## **LEIGHTON PLACE SUBDIVISION, PHASE TWO**

APPLICATION NUMBER 25 DATE October 3, 2013

REQUEST Subdivision

# SITE PLAN

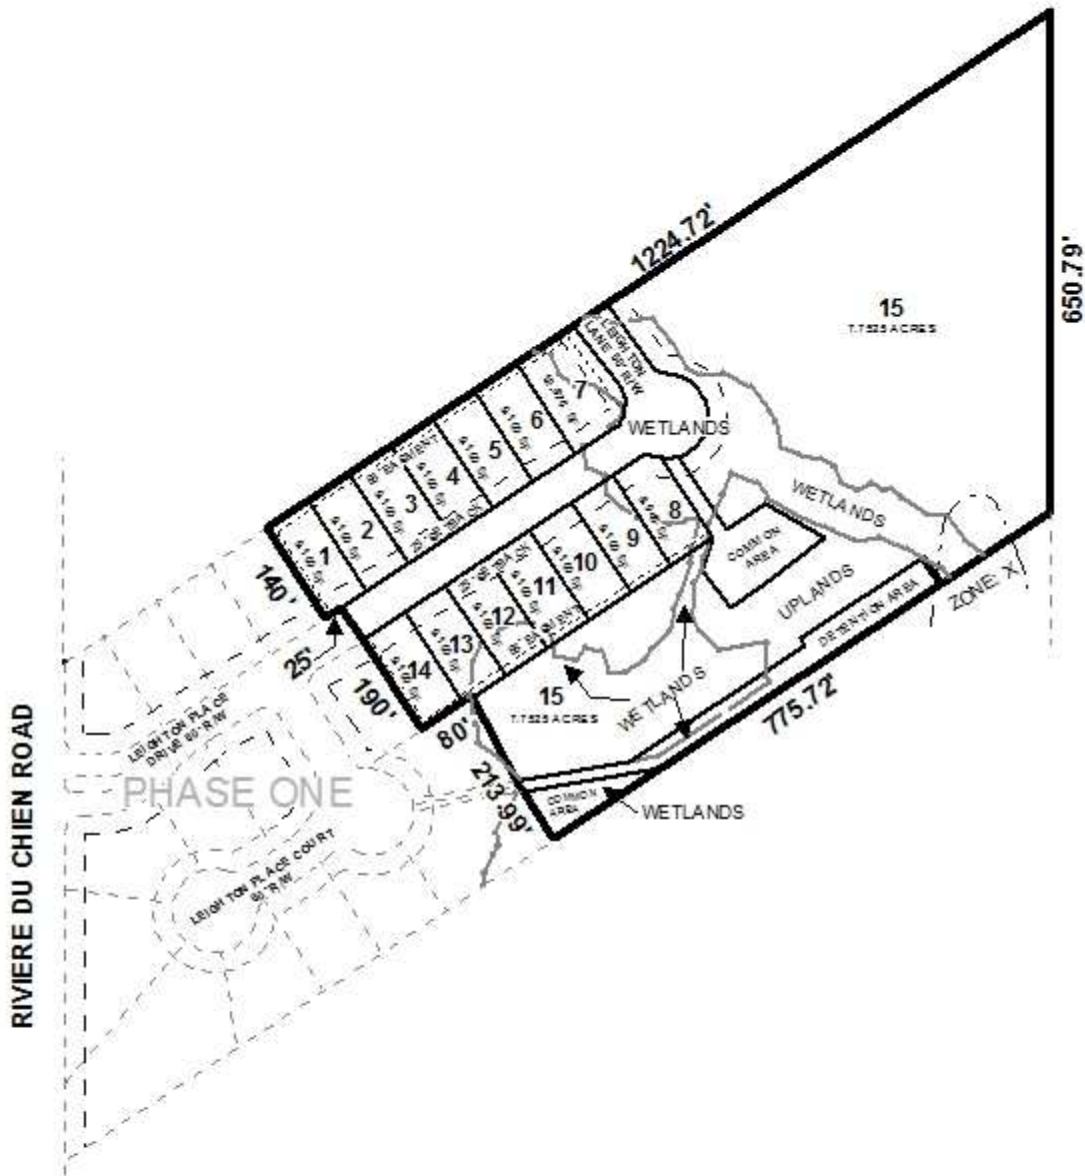
The applicant is proposing 15 lots. Lots 1 through 14 with a minimum lot size of 8,946 square feet encompass approximately 4.75 total acres and are proposed for residential use. Lot 15 is composed of the remaining 7.75 acres of the site, much of which is wetlands. Each lot will meet the minimum area requirement for properties served by water and sewer systems. As on the preliminary plat, Lots 1 – 14 should be labeled with their size in square feet, and Lot 15 with its size in both square feet and acres, or a table should be furnished on the final Plat providing the same information. All lots will meet the minimum frontage width requirement of 60-feet. Proposed Lot 7 is a corner lot with increased width and size to allow for the 25' minimum building setback along both street frontages. The rear dimension on the plat for that lot indicates a 65' width; however, as this lot is actually wider than the other lots dimensioned at 65' width, the rear dimension for this lot should be corrected on the Final Plat.

Each lot should be limited to one curb-cut, with the size, design and location to be approved by Traffic Engineering and conform to AASHTO standards. A common area (detention pond) is also proposed with a 20' access off the cul-de-sac, and in order to facilitate access for maintenance, the common area should be limited to one curb-cut, with the size, design and location to be approved by Traffic Engineering and conform to AASHTO standards. A note should be required on the Final Plat stating that the maintenance of the common area (detention area) is the responsibility of the property owners.

Drainage and utility easements are indicated within all lots; therefore a note should be placed on the Final Plat, if approved, stating that no structure may be built within any easements.

- 1) revision of the plat to reflect compliance with Section V.B.14. of the Subdivision Regulations for a 60' radius cul-de-sac without a central median;

- 4) revision of the plat to accurately depict the rear width on Lot 7;
- 5) retention of the 25' minimum building setback line along all street frontages;
